Service Bulletin No. CO20050706 Rev A
Subject: Volute and Drain Cover Change
Model: QP- 3TE, QP- 3TH
Product Group: Trash Pumps
Date: 06 Jul 2005

SERVICE BULLETIN

Series/Parts Affected: QP-3TE and QP-3TH Trash Pumps

Old Style (2-post)

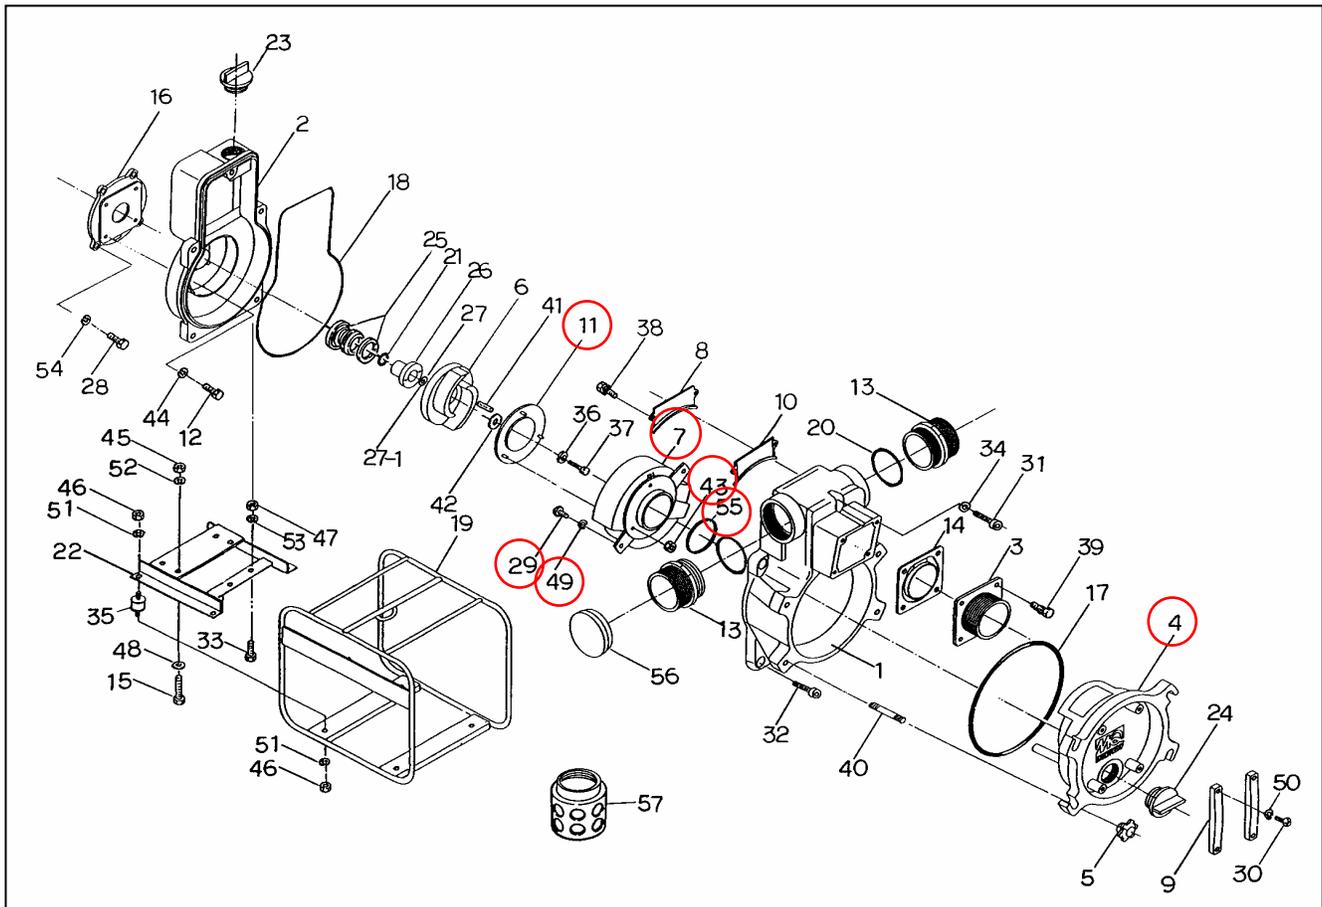
The volute under certain conditions would loosen from the drain cover creating excessive wear on the impeller and possibly damaging the impeller. The volute and drain cover design was changed from a 2-bolt fastening system to a 4-bolt system. This problem did not occur in all pumps, usually the problem was noticed very soon after a new pump was placed into service.

If the volute is ever removed from the drain cover use the following procedure to assure the volute cap screws are re-attached properly:

- Use Loctite thread cleaner on cap screws before re-using
- Use Loctite # 243 on volute cap screws and tighten to torque of 130-160 in-lbs.
